<b>Date</b>	<b>06/02/2020</b>
<b>Produit concerné</b>	<b>T-Bone links</b>
<b>Niveau</b>	<b>medium</b>

**KORTEL  
DESIGN**

## ***SAFETY NOTE***

***Non conformity of T-Bone link***

**Non-compliant**

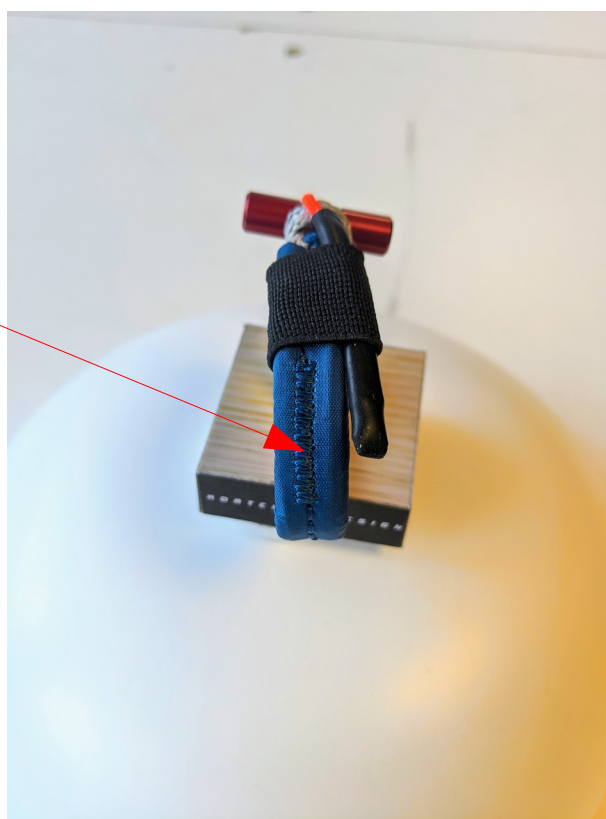
In randomized tests on the strength of T-Bones links, we have just found a break at a value lower than the assumed 24KN.

After analysis, this is a production error in the manufacturing process of the T-Bones link, which is difficult to detect during routine checks.

The T-Bone links in question have a break of between 16 and 18KN.

However, due to their non-compliance with the 24KN announced, we are recalling and exchanging all T-Bone links delivered as a stand-alone product or with the Kruyer III since October 2019.

For simple identification, all T-Bone links with a blue safety bartack seam, the same colour as the protective fabric, are to be considered non-compliant.

The next T-Bone links will be made with a different color bartack to identify them.
